UTPB - VALET AND DRIVEWAY RENOVATION
6410 Fannin Street/ Houston, Texas 77030

Date: December 16, 2019
Johnston Project No.: 19-00032-00
Prepared by: Paula Gaviria

1. This Addendum addresses architectural, mechanical and electrical revisions as noted below, per comments from EH&S:

SHEET:
G1.00

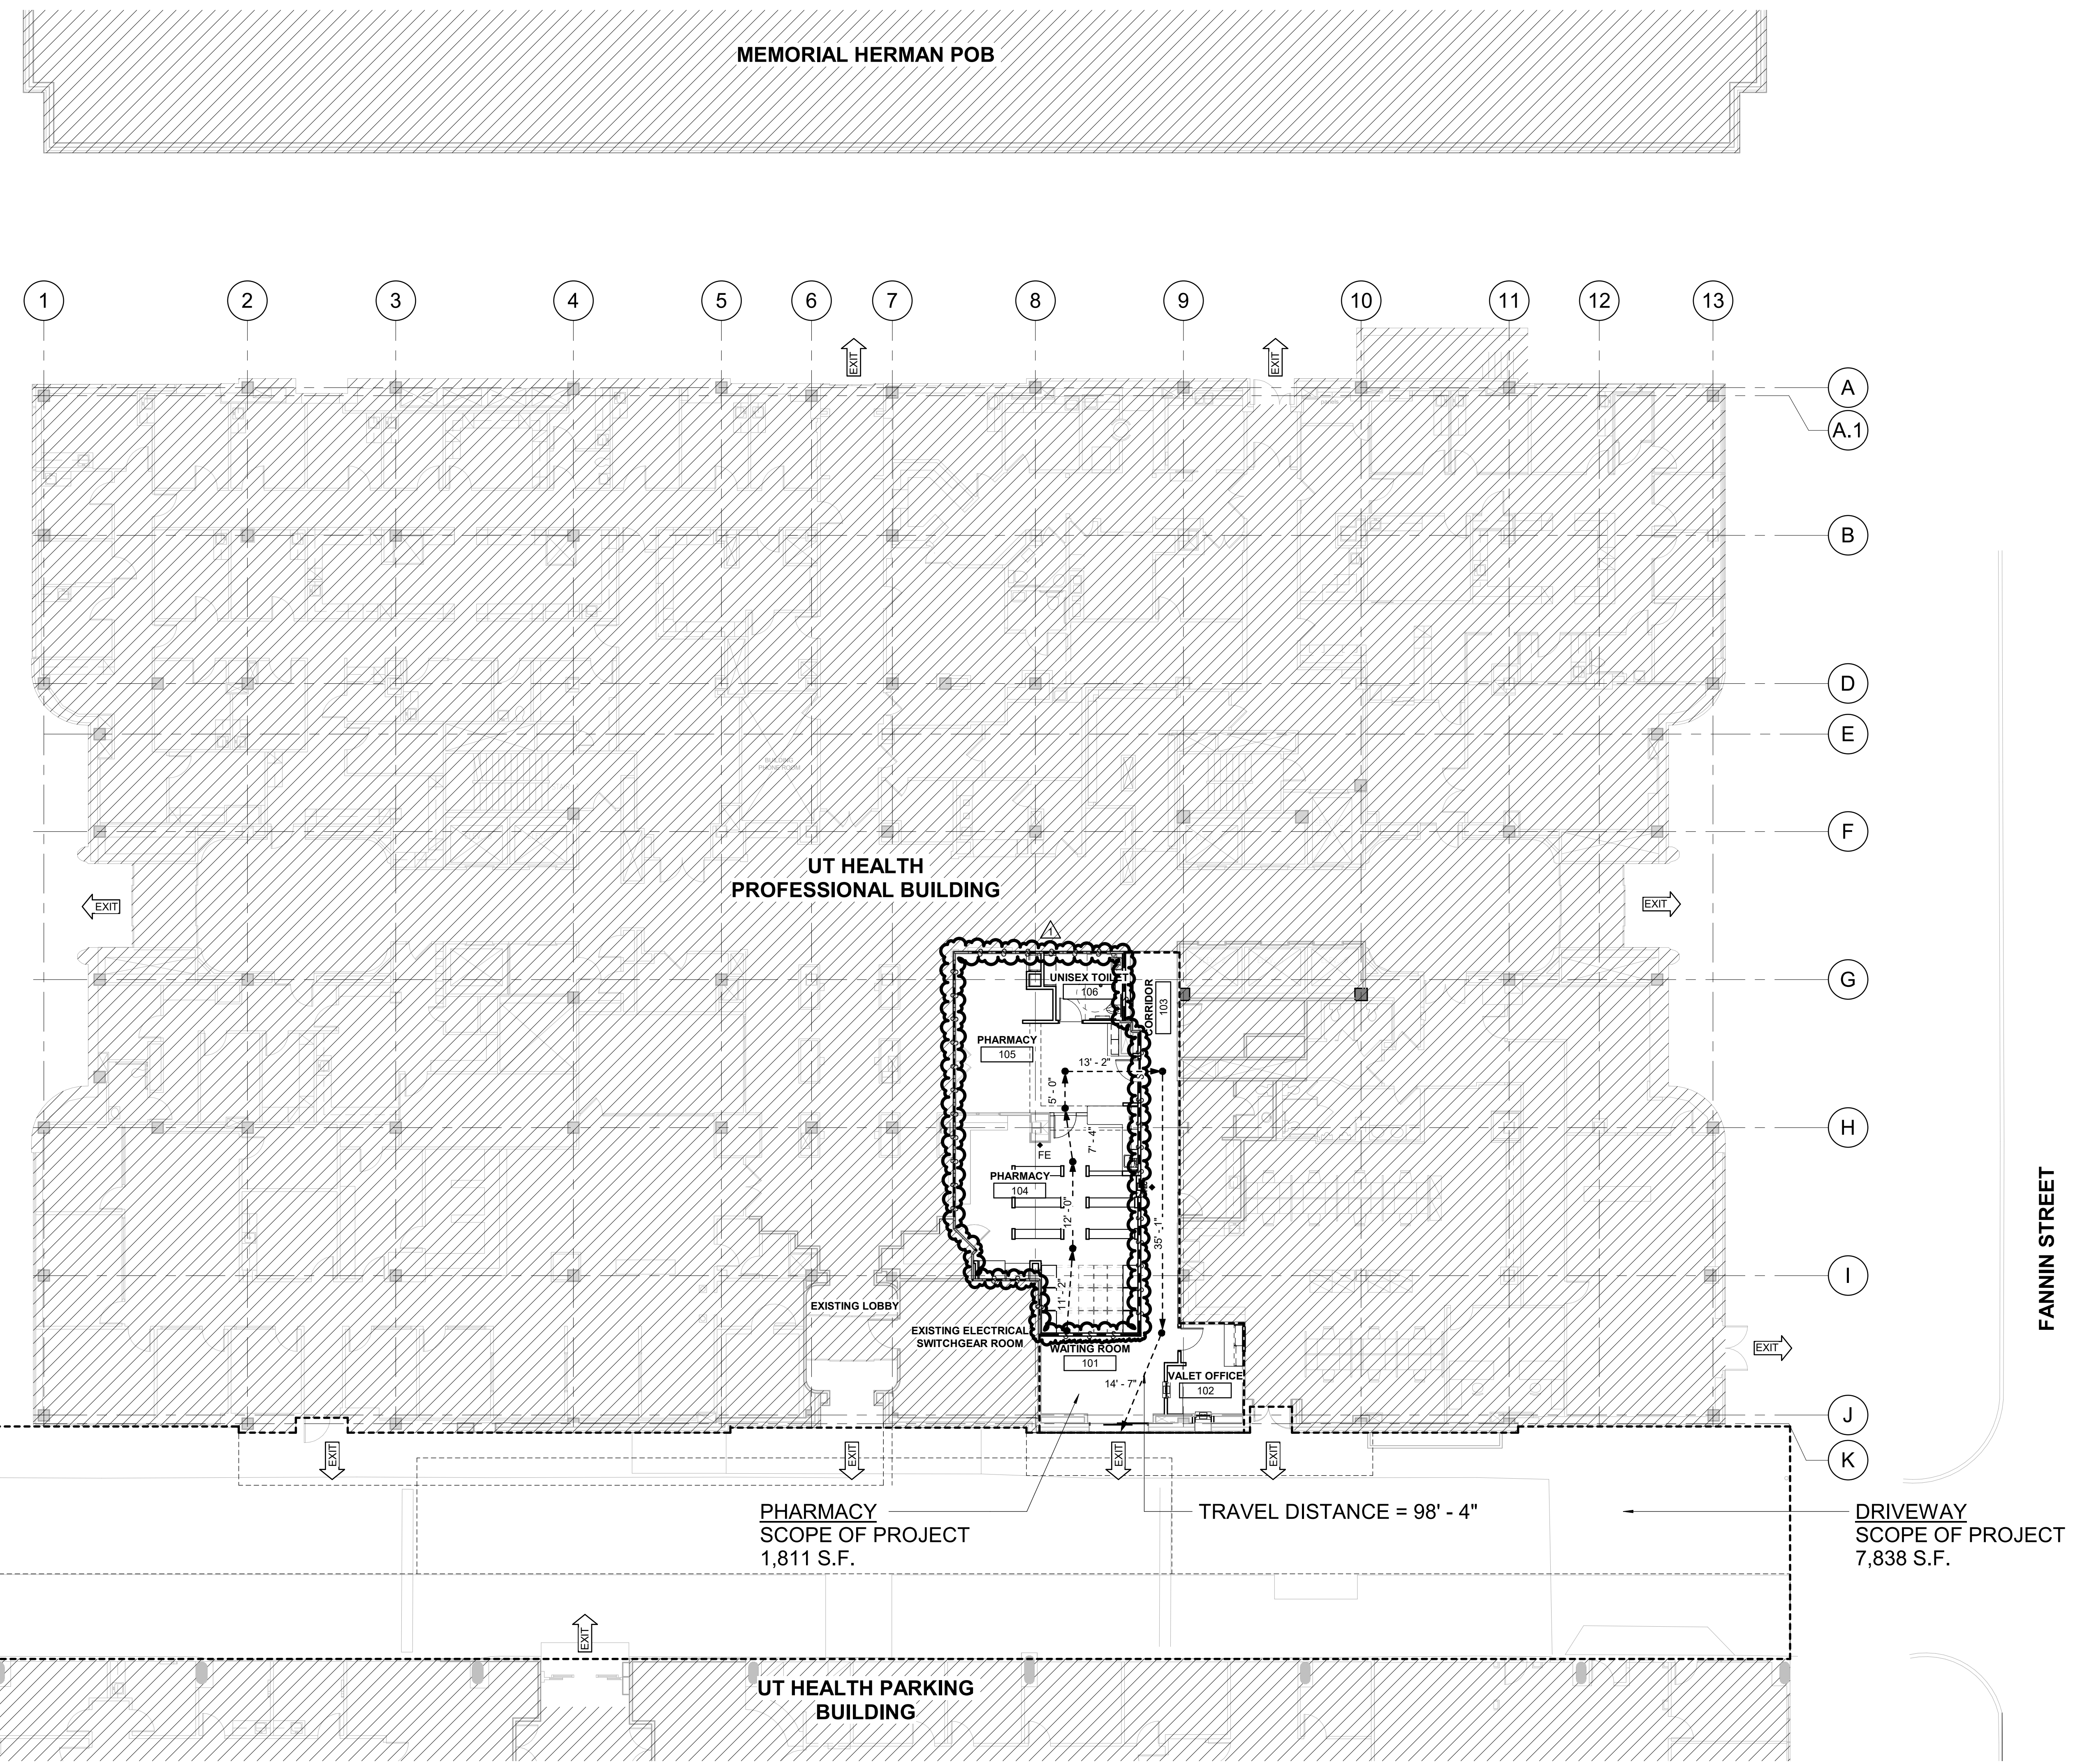
1. G0.00: COVER
 - Revised the name of the issue.
2. G0.01: DRAWING SHEET INDEX
 - Added Addendum #01 column and checked the sheets that are being issued.
3. G1.00: LIFE SAFETY PLAN
 - Revised existing and new fire tapes as smoke partitions.

SHEET:
A1.01

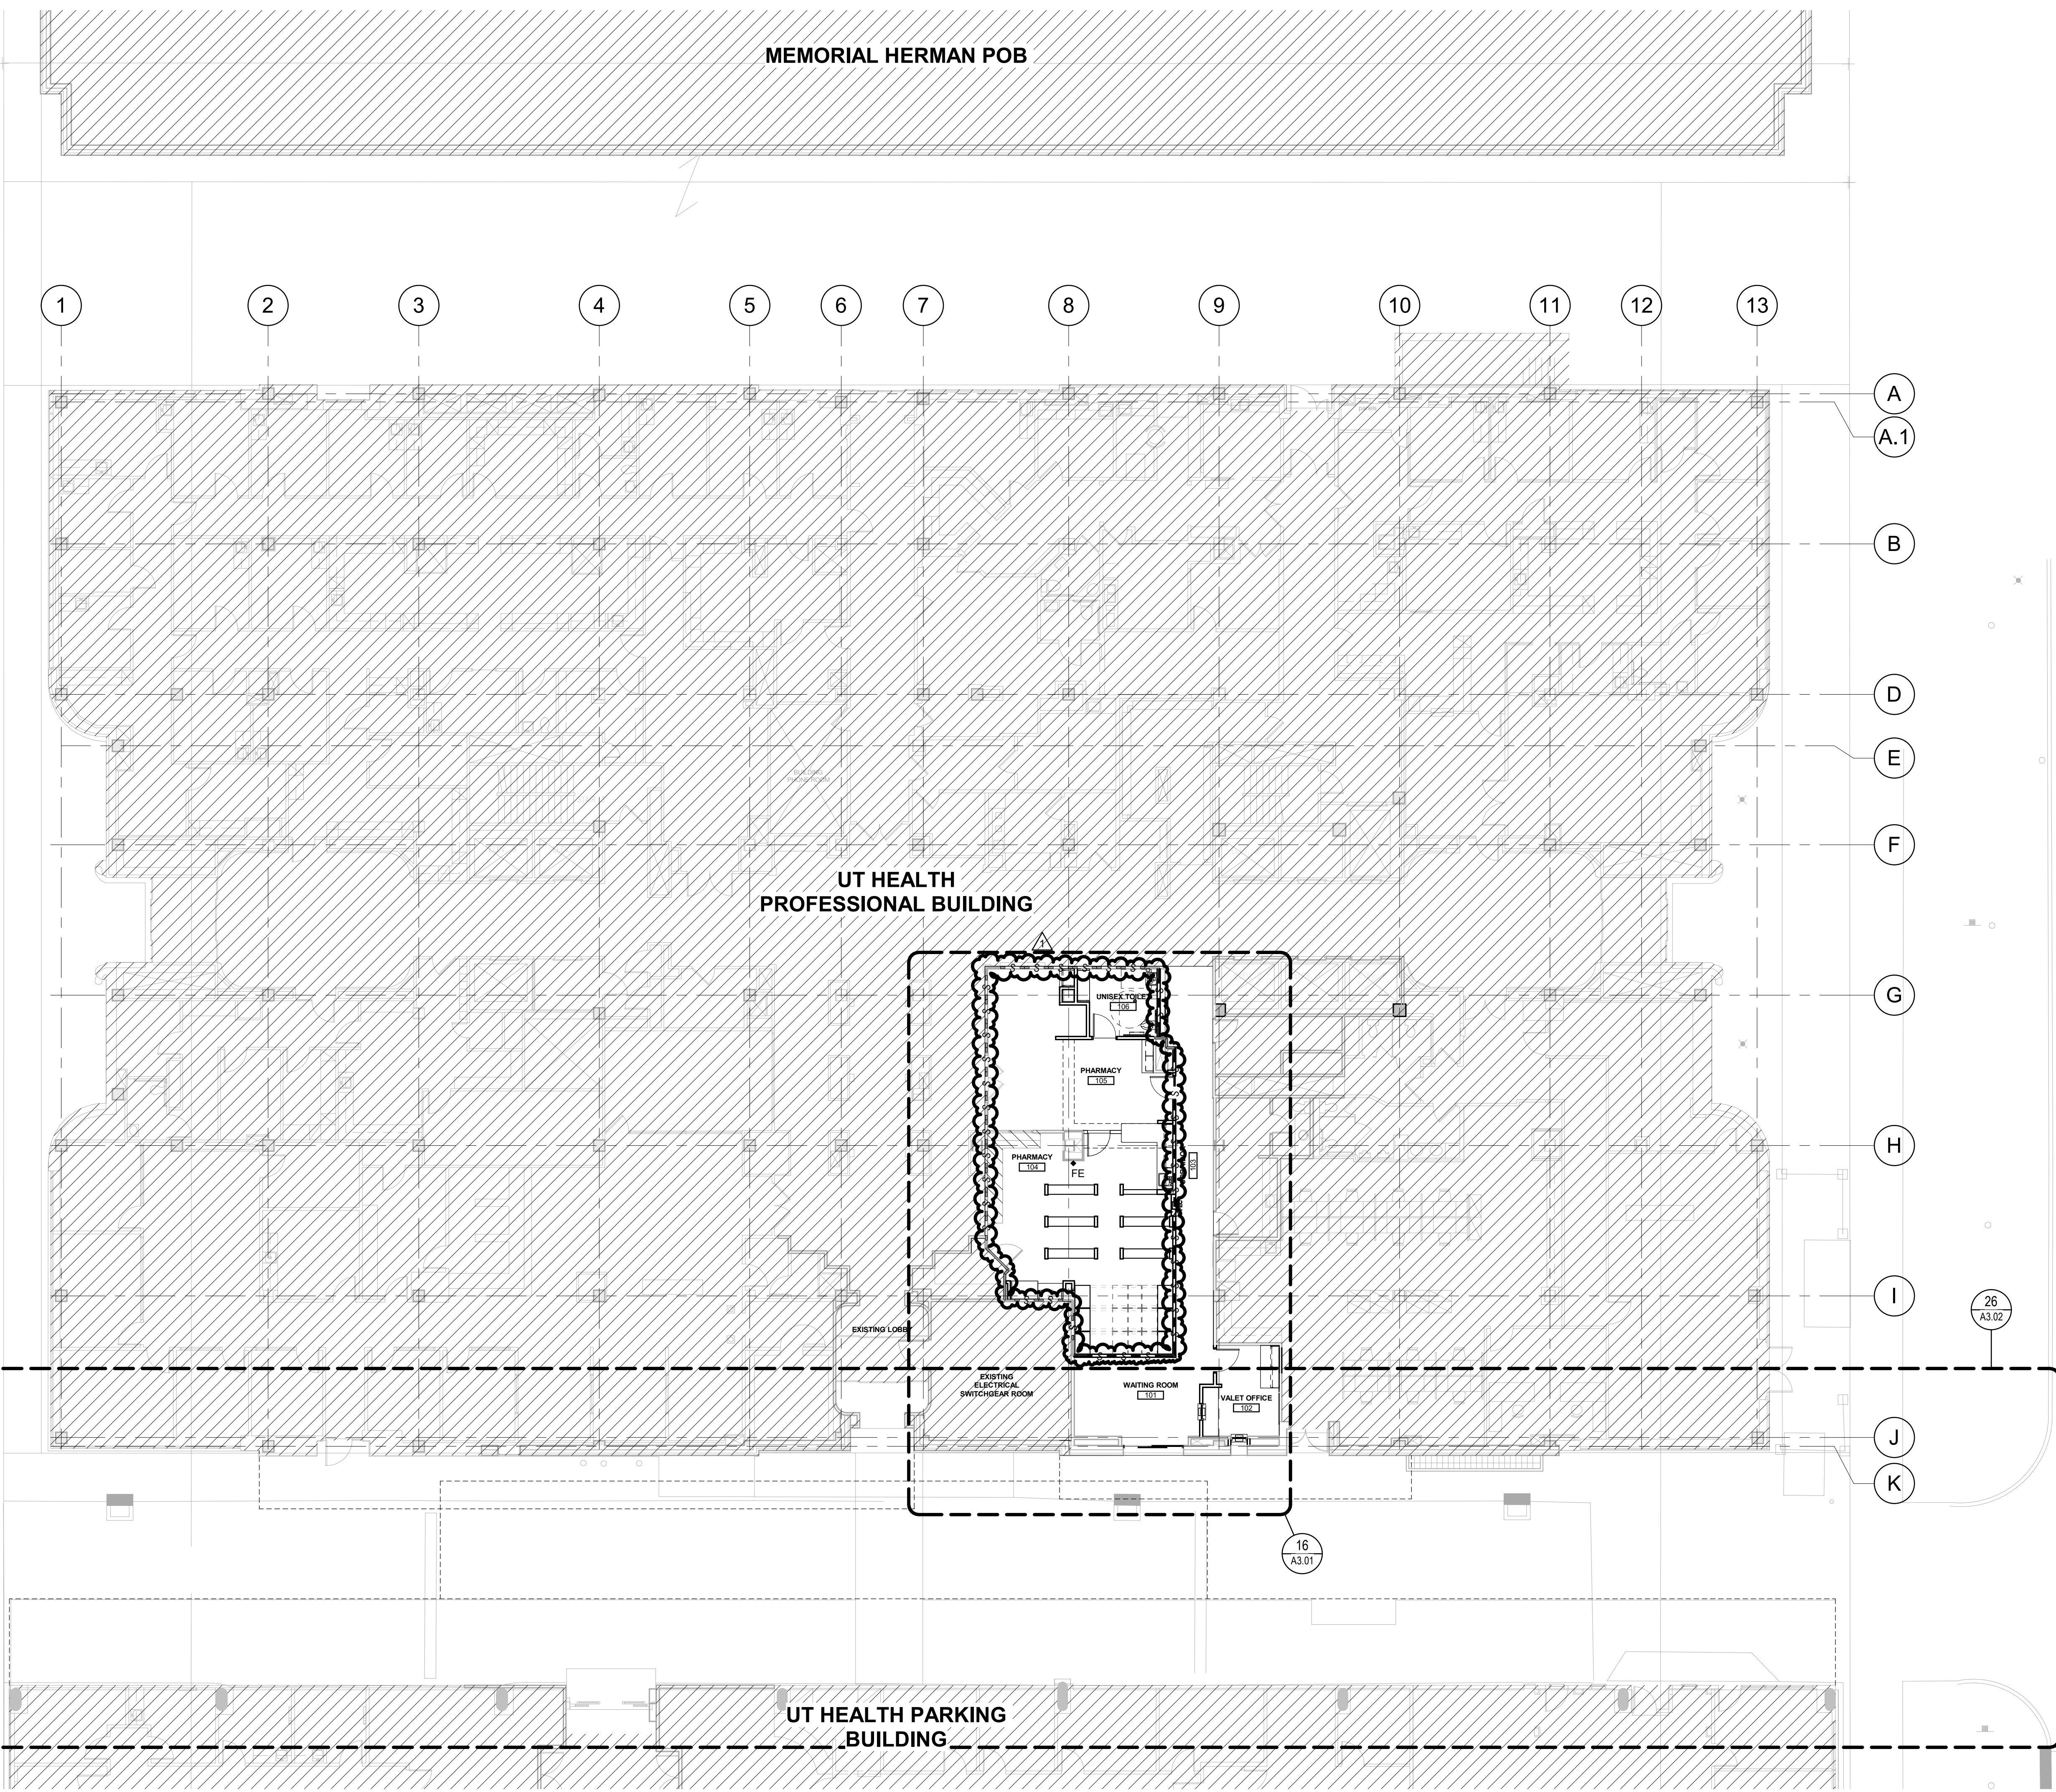
1. A1.01: OVERALL FLOOR PLAN
 - Revised existing and new fire tapes as smoke partitions.
2. A3.01: ENLARGED FLOOR PLAN & REFLECTED CEILING PLAN – INTERIOR
 - Revised existing and new fire tapes as smoke partitions.
 - Revised wall types to be smoke partitions.
 - Added exit sign to Corridor 103.
 - Added Fire Rated Legend to sheet.
 - Added a smoke detector in Pharmacy
 - Added and relocated fire strobes.
3. A10.04: PARTITION TYPES
 - Added wall type SA to sheet.
 - Removed wall type 1A from sheet.
4. A11.01: OPENING SCHEDULE
 - Revised door 105.1 and 106.1 fire rating.
